CDM: Recommendation Form for Small Scale Methodologies (version 01)

Date of SSC WG meeting:	10–12 November 2008, SSC WG 18
Title/Subject (give a small title or specify the subject of your submission, maximum 200 characters):	Applicability of AMS-II.B for improvement of energy efficiency in the natural gas supply system of the combined cycle gas turbines
Indicative methodology to which your submission relates (refer the items of Appendix B of the Simplified Modalities and Procedures), if applicable.	AMS-II.B
Name of the authors of the query:	Mariela Beljansky Institution: AES ALICURÁ S.A. mbeljansky@eco-energia.com.ar

Diagrammatic representation of the baseline and the project activity

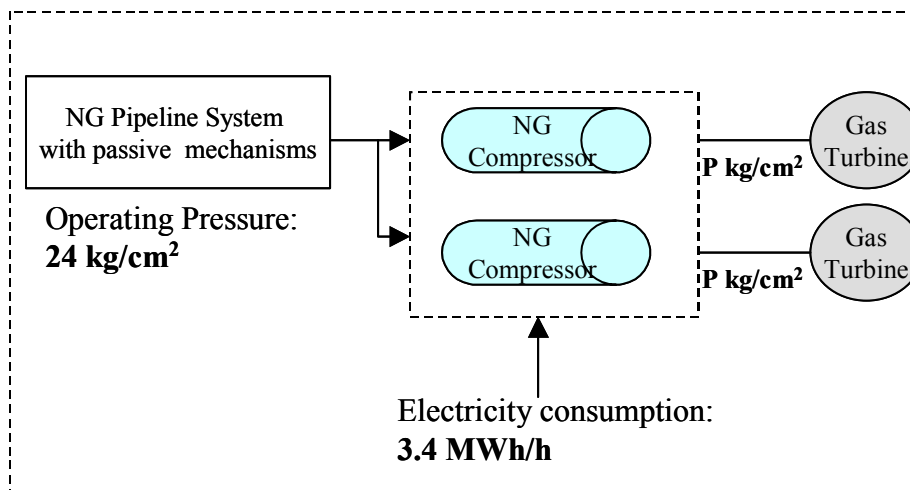
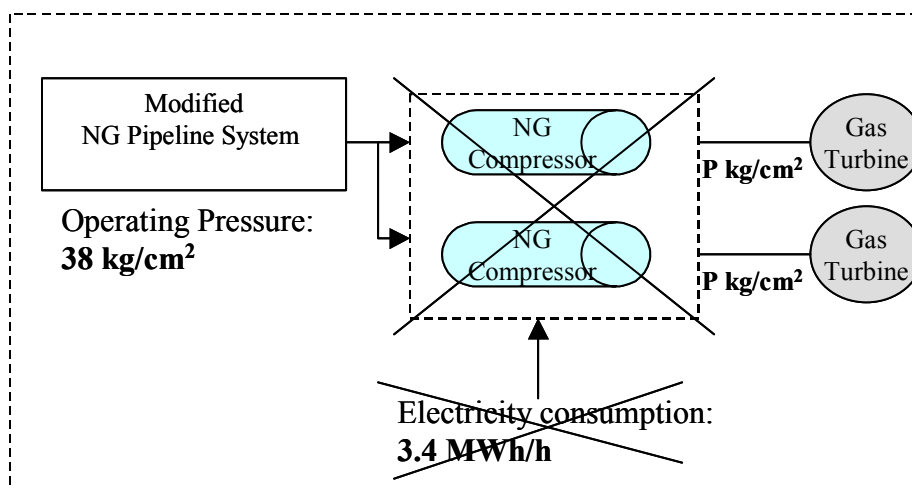
It is understood from the submission that the project activity will involve the modification of the natural gas supply pipeline connecting the electricity generating units to increase the maximum allowable operating pressure from 24 kg/cm^2 to 38 kg/cm^2 . With the implementation of the project activity, the onsite gas compressor facilities will no longer be continuously operated, as the gas pressure will be adequate for direct supply as fuel to the power generating Gas Turbines, thereby saving electricity consumption.

Further, it is not clear from the submission whether all the project energy use has been considered in the estimation of energy saving/consumption of the project in order to justify that it is indeed an energy

efficiency project. For example, the project activity involves the improvement of gas pipeline in which no information on energy use on implementing this technology/measure has been provided.

The SSC WG is of the opinion that a new methodology may have to be proposed to include all components of the proposed project activity with appropriate and reliable monitoring procedures and possible leakage associated with the project development.
